**Re: Lot 10 Block 9 Unit 22 Volcano Cliffs, S.A.D. 228
6401 Petirrojo Rd. NW
Request Permanent C.O. – Not Accepted
Engineer's Stamp dated: 4-11-17 (D10D003Q101)
Certification dated: Not Provided**

LOT 10, BLOCK 9, UNIT 22
VOLCANO CLIFFS SUBDIVISION

CANDELARIA - COMPOS - GRADING & DRAINAGE PLAN

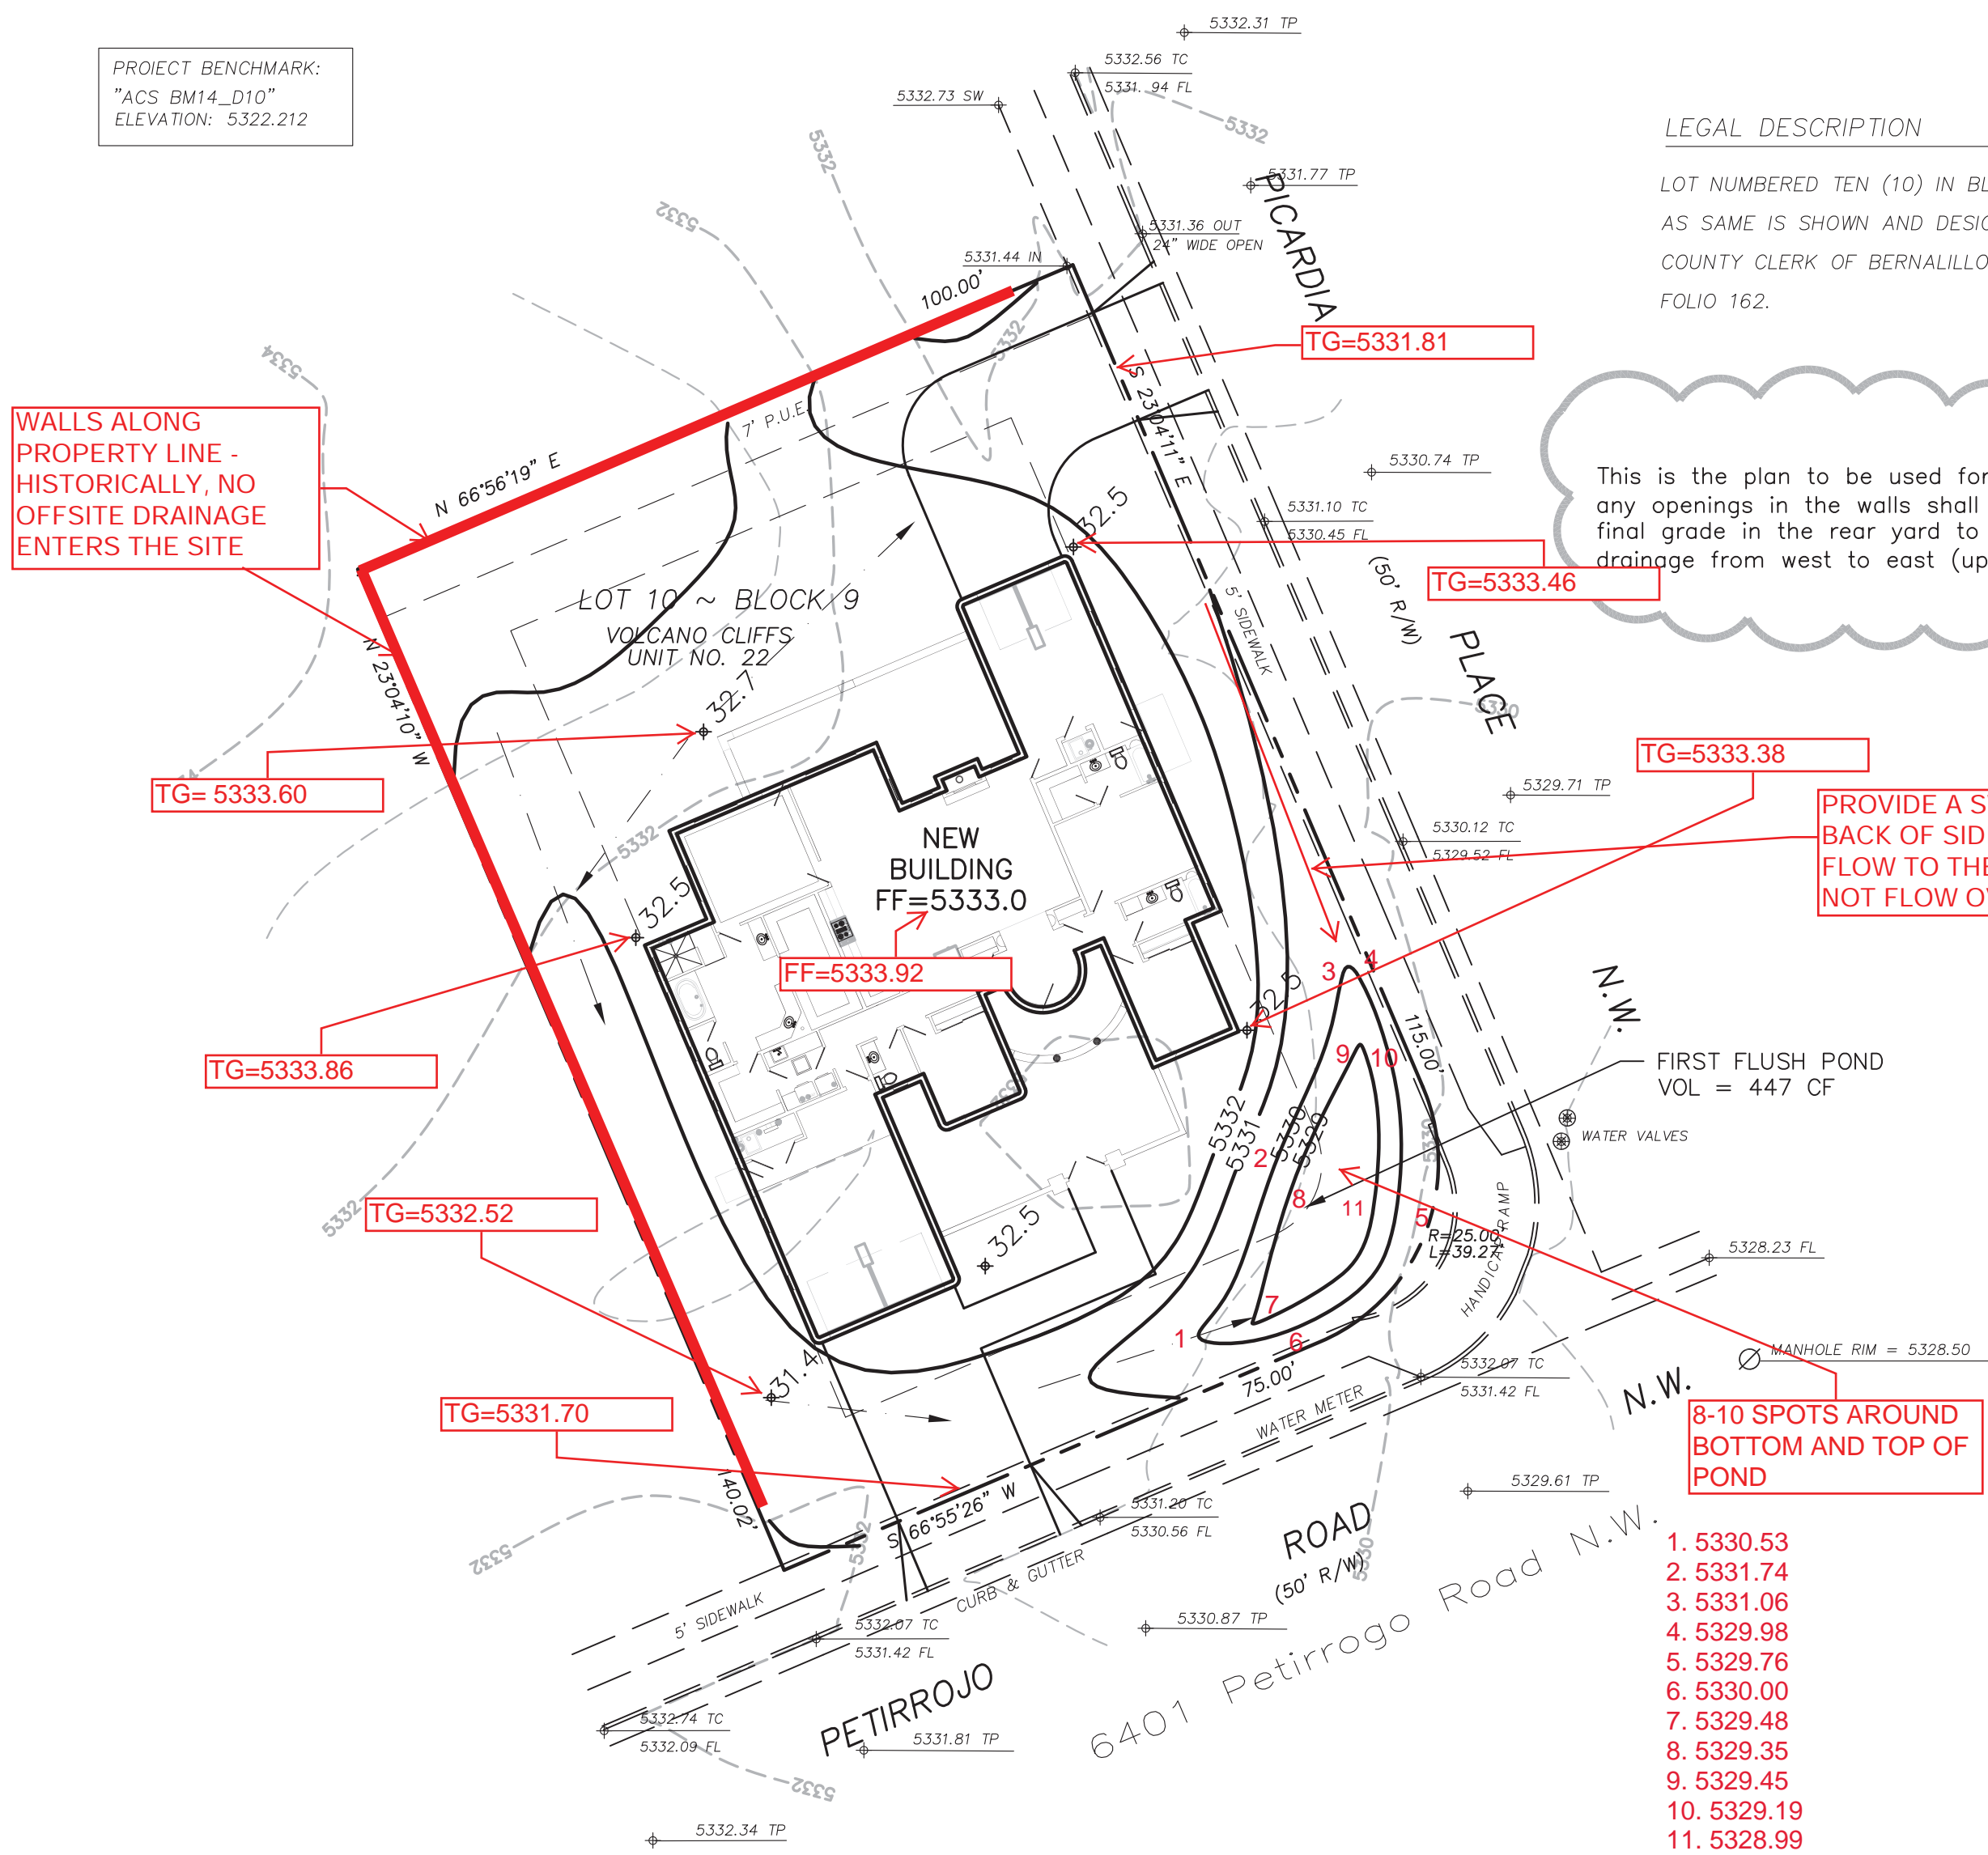
Based on the Certification received 10/23/2017, the site cannot be accepted for release of Certificate of Occupancy by Hydrology until the following comments are addressed.

- Provide the Certificate of Occupancy statement on the plan.
